Access Compliance Report Public Rights-of-Way (Curb Ramps)

Main Street: N/A Cross Street: ASCENSO_AVE Location: W

ADA ID: RPRK211122130928 Ramp Type: Type 6 - Directional 1 Initial Pass/Fail: Pass Overall Compliance: No Severity Score: 5

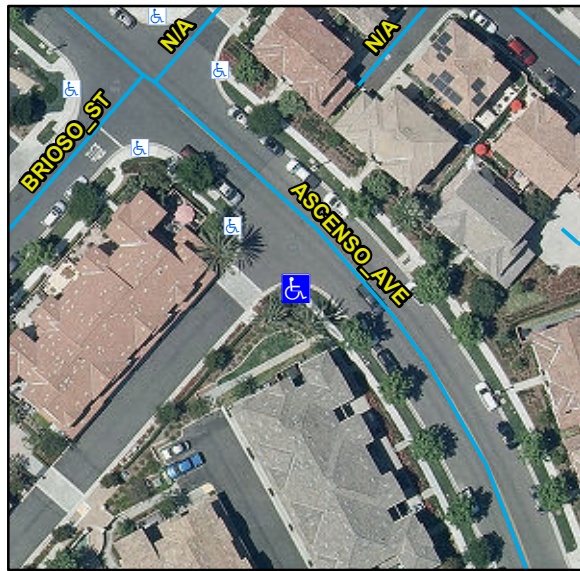
Marked Crosswalk 1 Width (in)	N/A			
N/A	Ramp Inside Crosswalk 1	N/A			
	Crossing 1 Slope (%)	3.7			
	Crossing 1 Cross Slope (%)	2.9			
Yes	Gutter Ponding	No	Yes	Curb Slope	6.7
Yes	Gutter Lip Height (in)	0		Road Run Slope (%)	N/A
No	Gutter Run Slope (%)	10.5		Road Cross Slope (%)	N/A
Yes	Gutter Cross Slope (%)	1.4		Parallel Ramp Side	Right
Yes	Overall Surface Condition	Acceptable	Yes	Perp Joint Present	Yes
	Cross Gutter Present?	No		Spandrel Present?	No
	Replace Cross Gutter?	N/A		Replace Spandrel?	N/A

Remove & Replace Gutter.
